1993 Corvette: Service Bulletin: Hood Will Not Open - Cable Disconnection

Subject: HOOD WILL NOT OPEN, CABLE DISCONNECTED
Model and Year: 1993 Corvette prior to V.I.N.'s: Non-ZR1 - P5110787 ZR1 - P5800217
Source: Chevrolet Service Bulletin
Bulletin Number: 93-151-10

TOOL

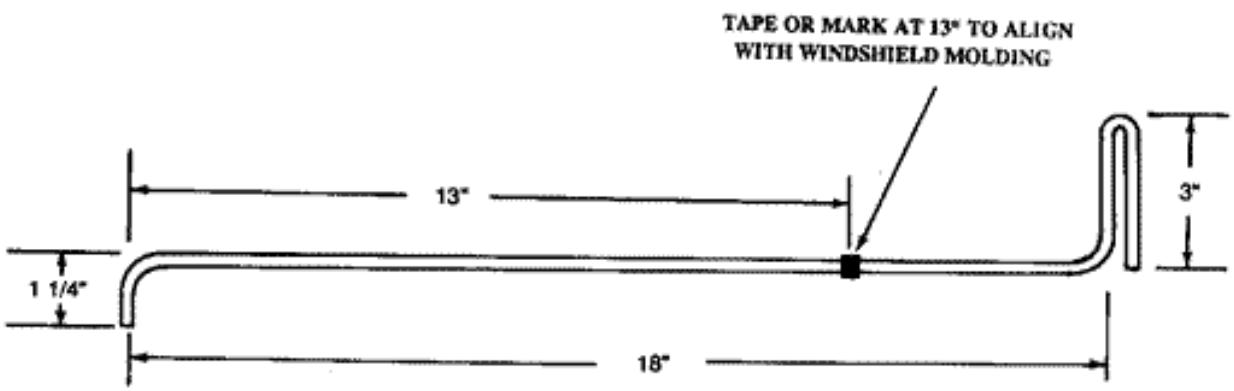
- Obtain material locally and fabricate the tool shown on the illustration from 3/16" or 1/4' steel rod.

TOOL IN POSITION
(DOOR REMOVED FOR ILLUSTRATIVE PURPOSES)

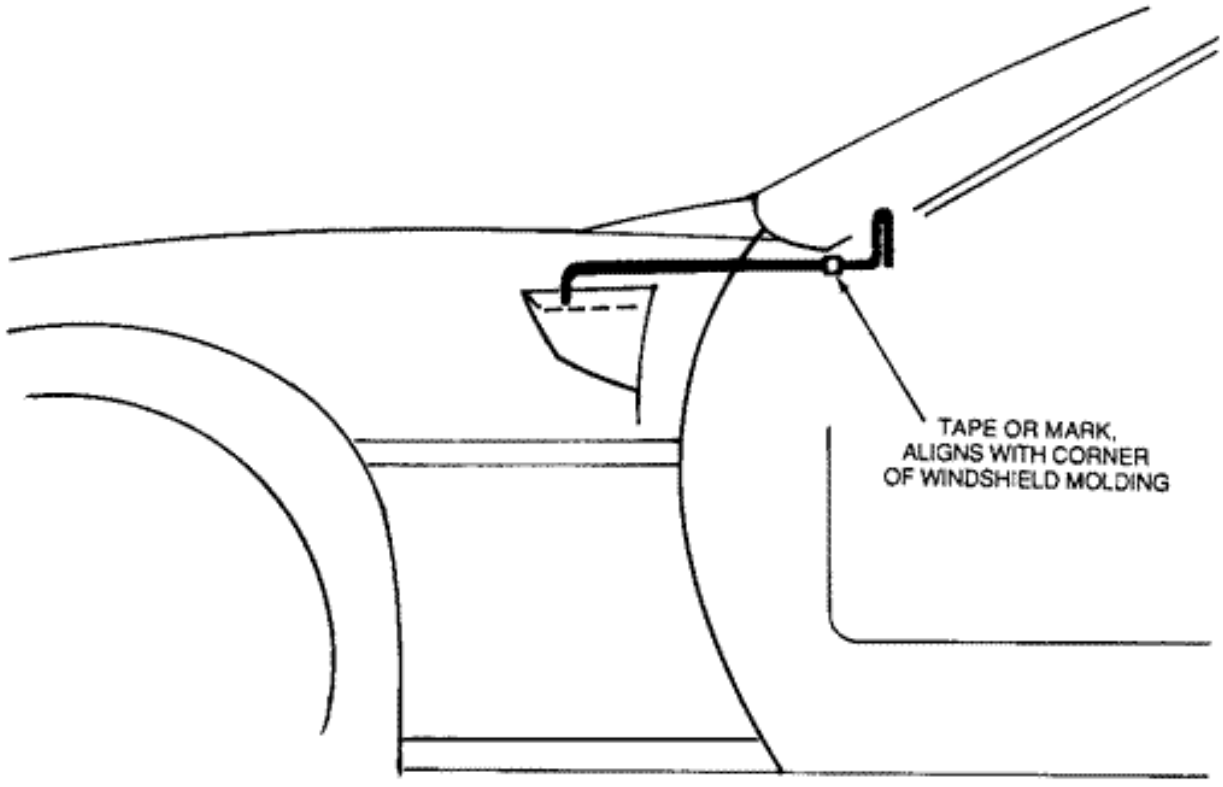
- With the door open, locate the short bent end of the tool inboard of the vertical flange of the hood latch support.

- insert the tool forward until the tape is aligned with the lower end of the windshield pillar molding.

- Twist the tool to contact and move the latch lever until the latch disengages. A slight downward pressure on the hood in the latch area may be helpful to disengage the latch lever.
